YEAR 4 MONITORING REPORT

UT MILLERS CREEK

DMS Project ID No. 95719, Contract No. 5000, USACE Action ID No. SAW-2013-00386

Re: NCDEQ – Division of Mitigation Services
UT Millers MY 4 Monitoring Report
UT to Millers Creek Draft Year 4 Monitoring Report
Cape Fear River Basin, CU 03030006, Duplin County, DMS Project No. 95719

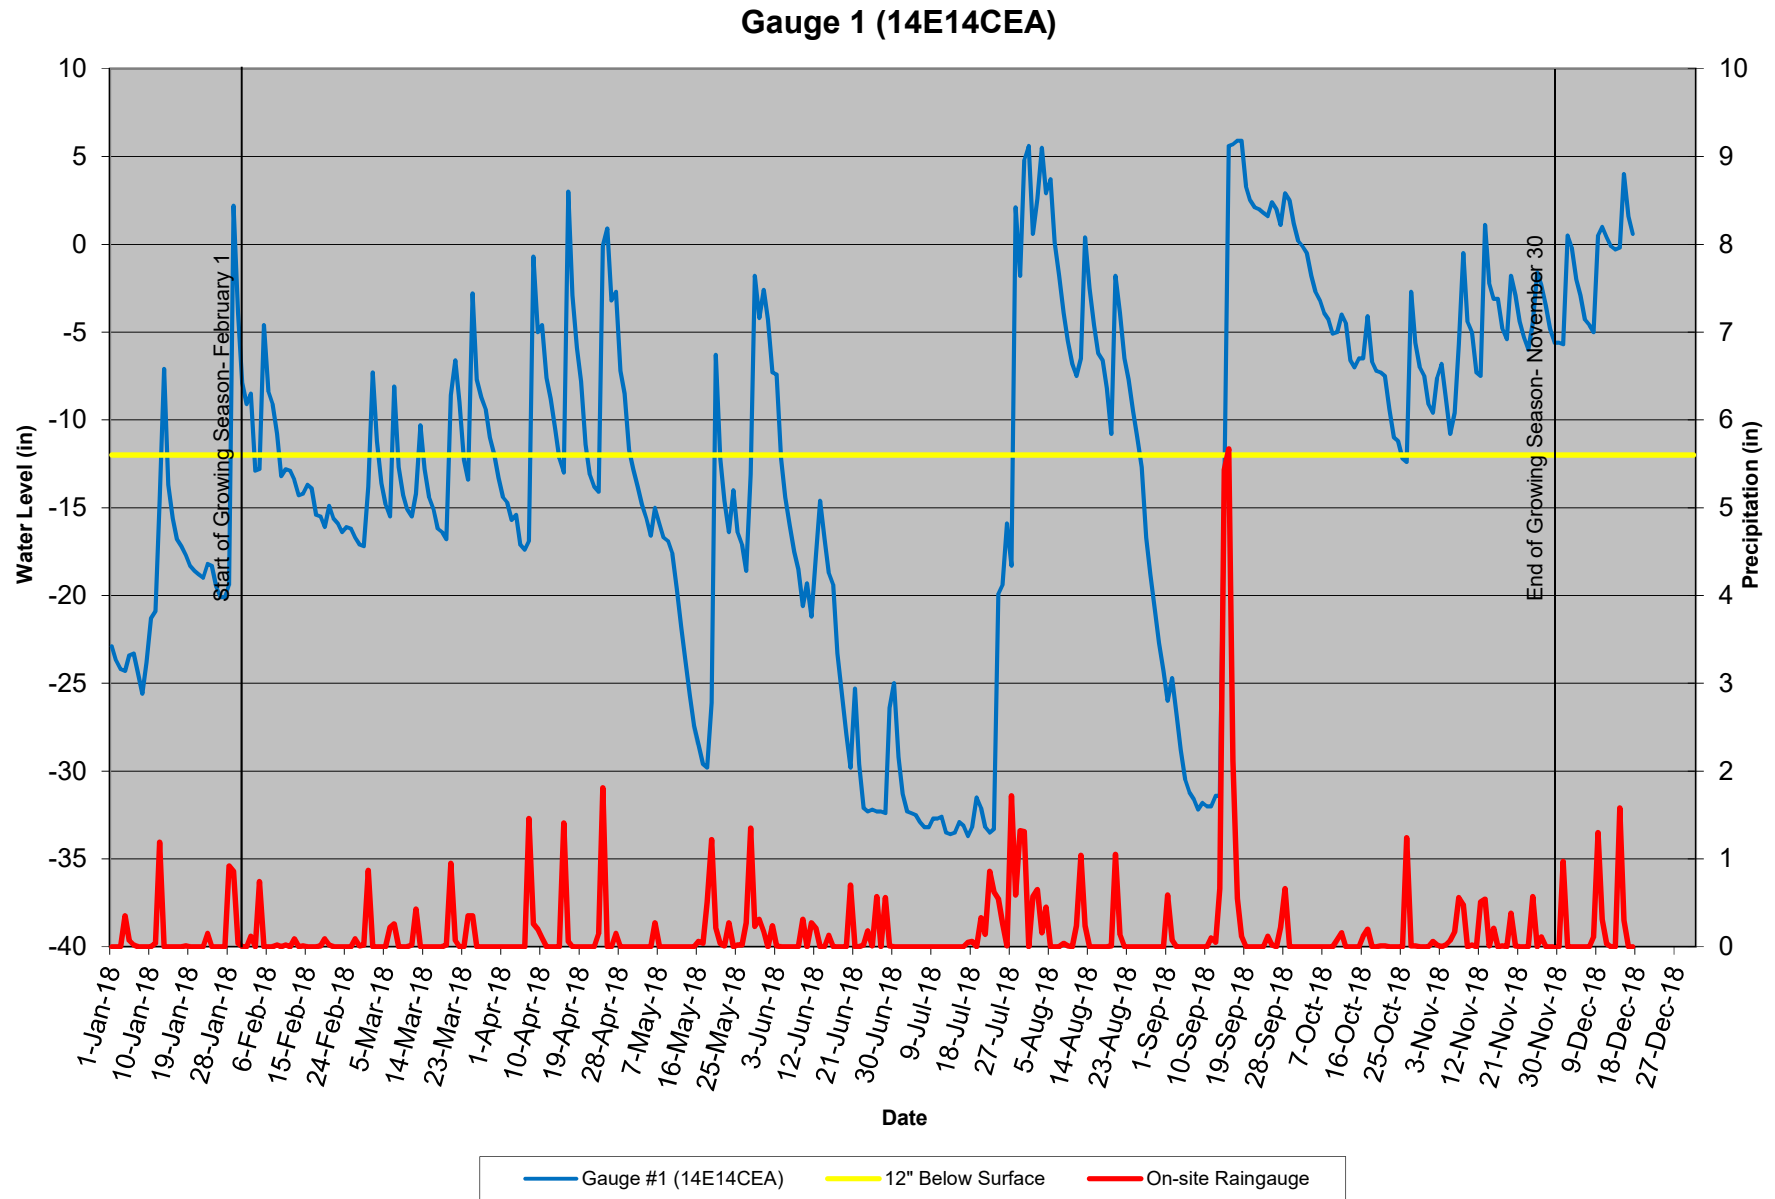
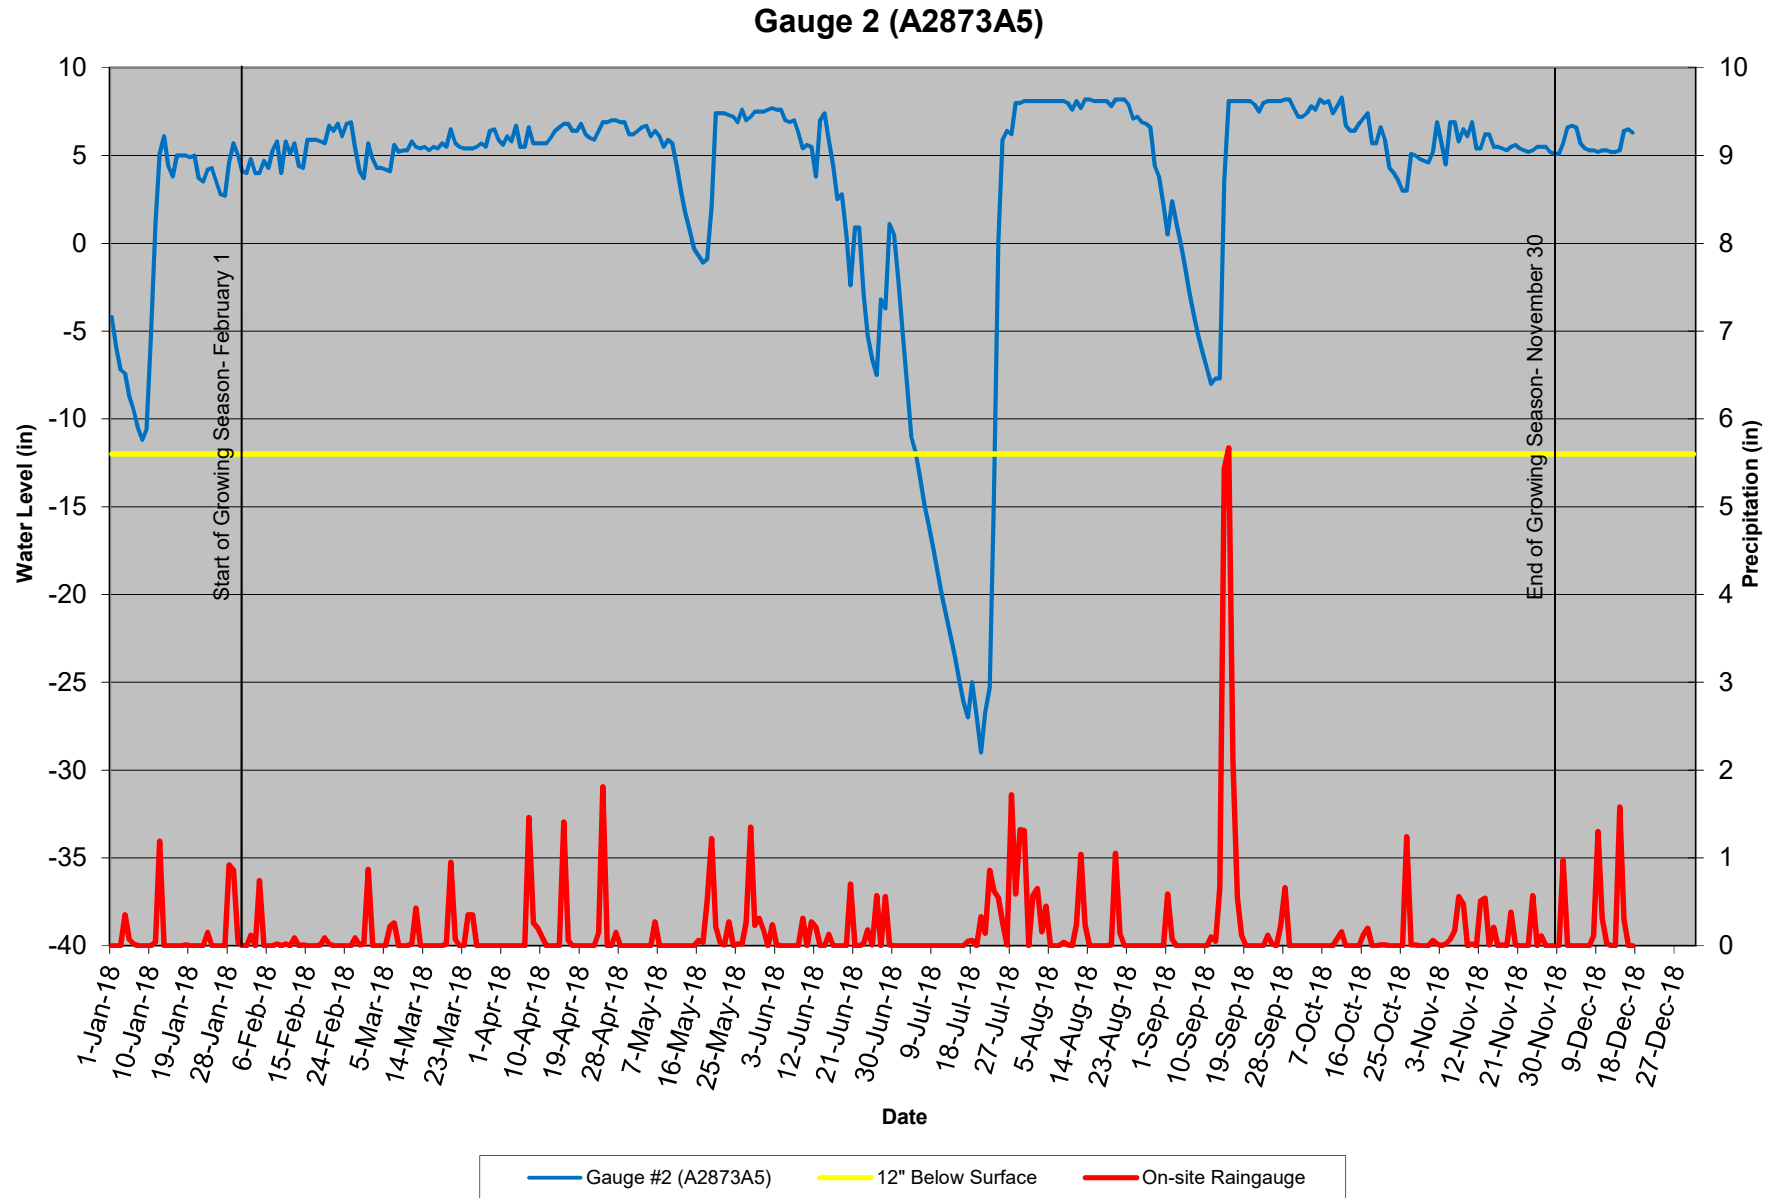
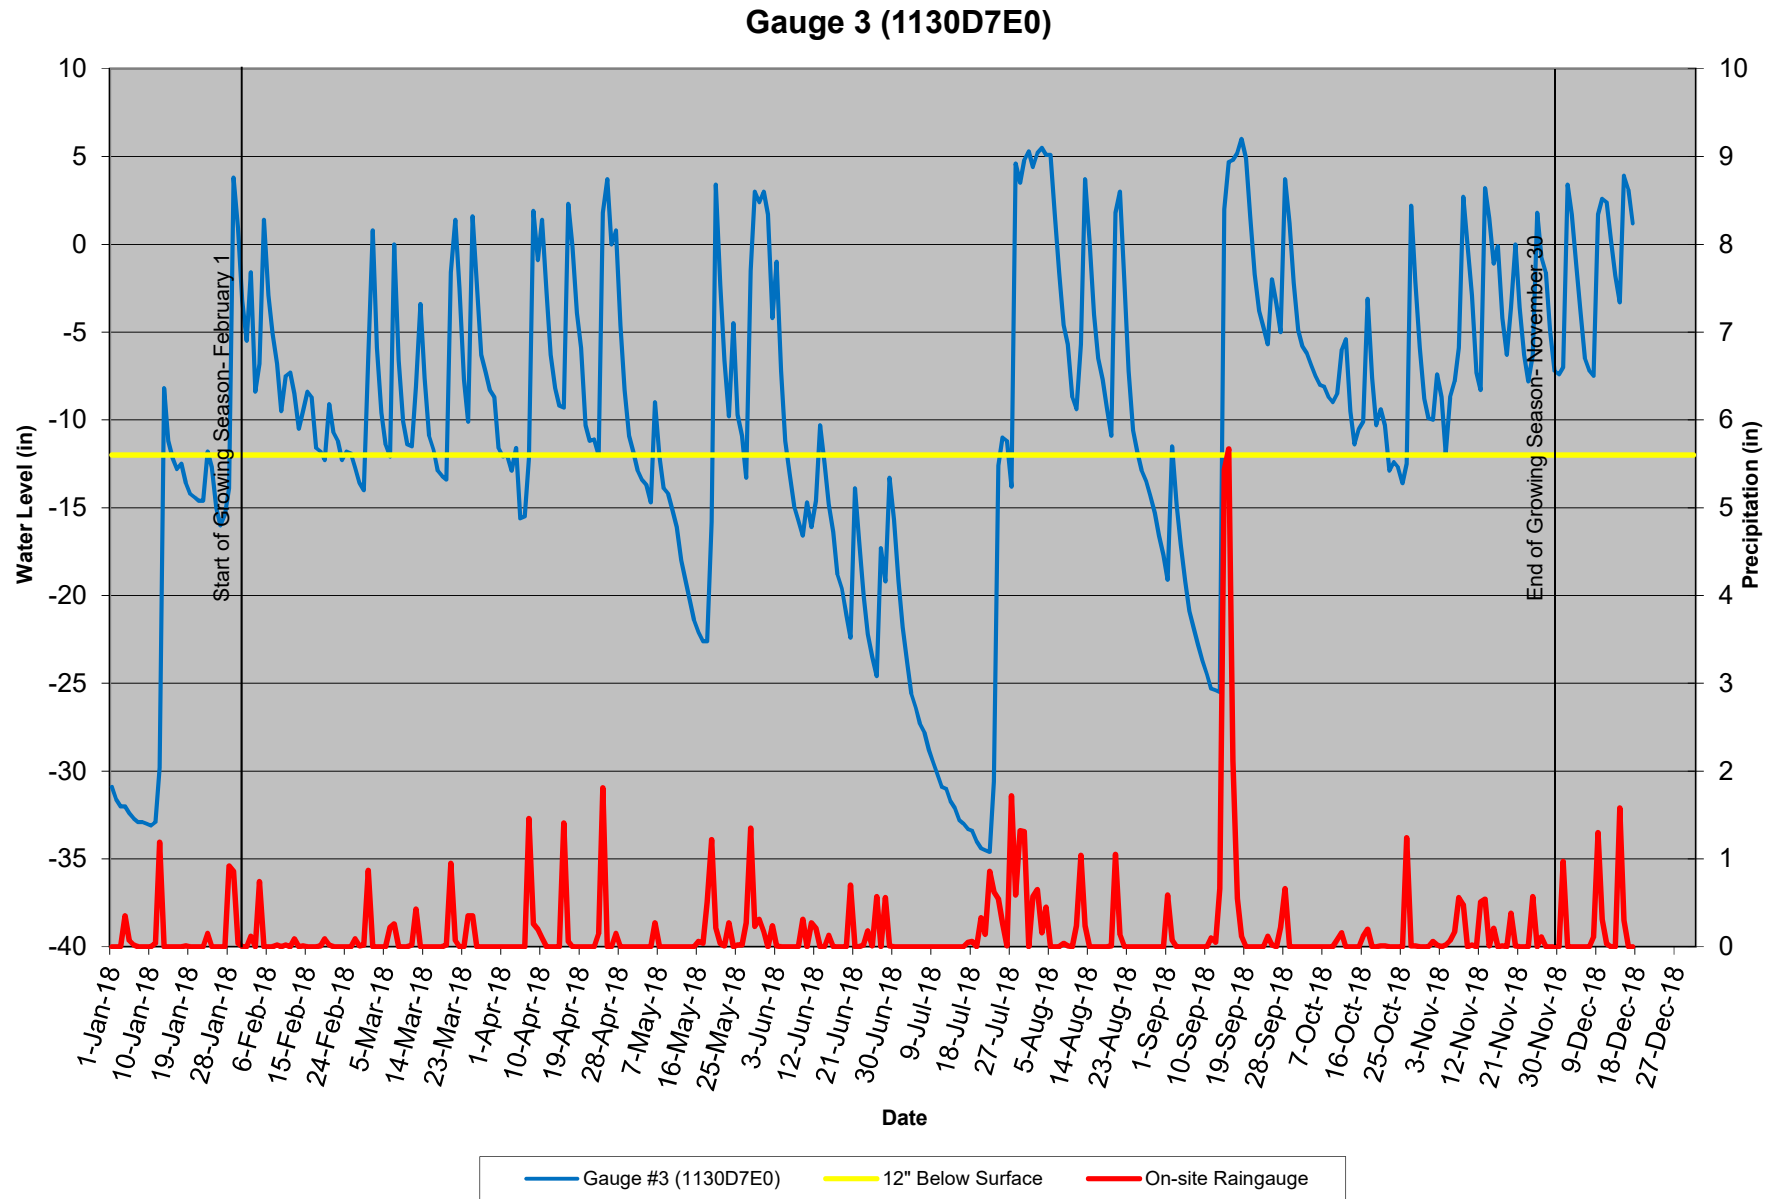
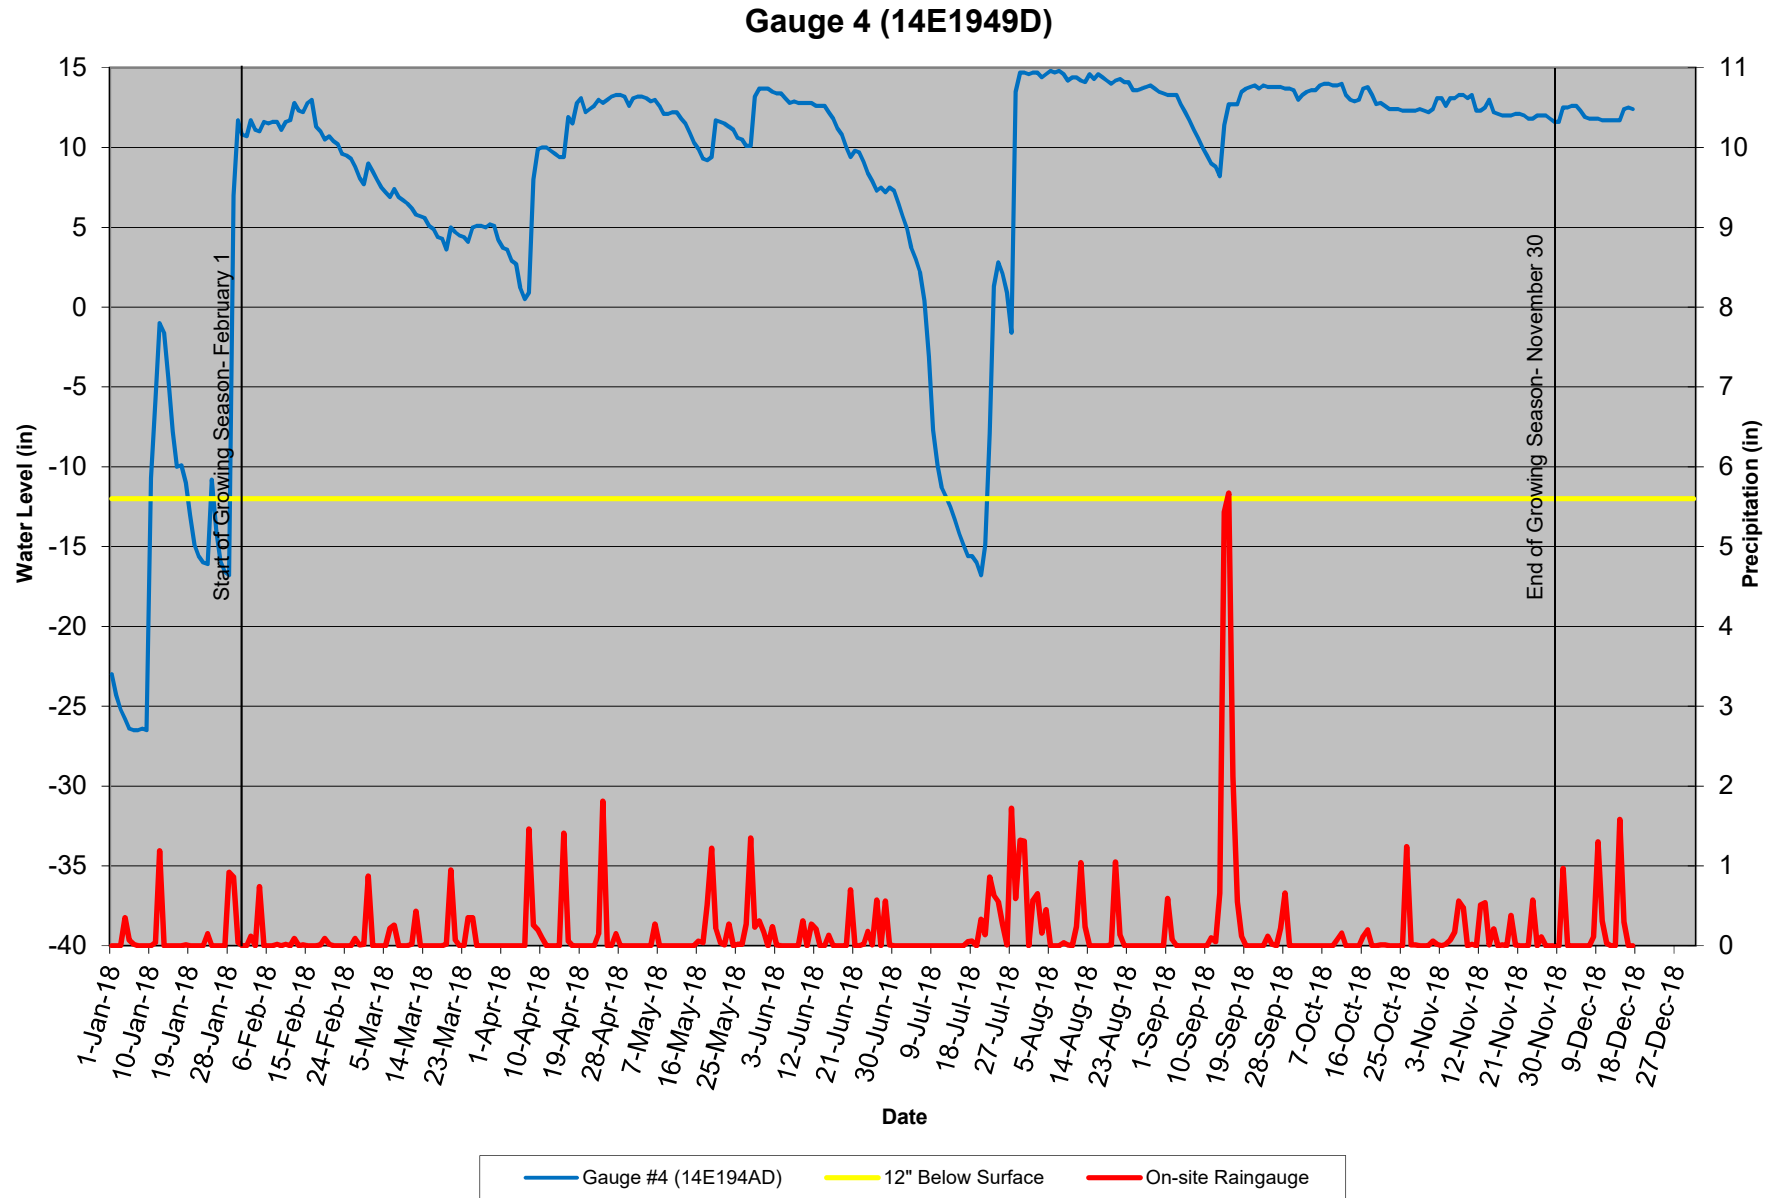
1. *Update hydrographs and Table 8 with data through the growing season (at least through 11/11). It is possible that the two gauges not meeting may achieve success during this time.*

The hydrographs have been updated through the entire year. All of the gauge locations are meeting success criteria.
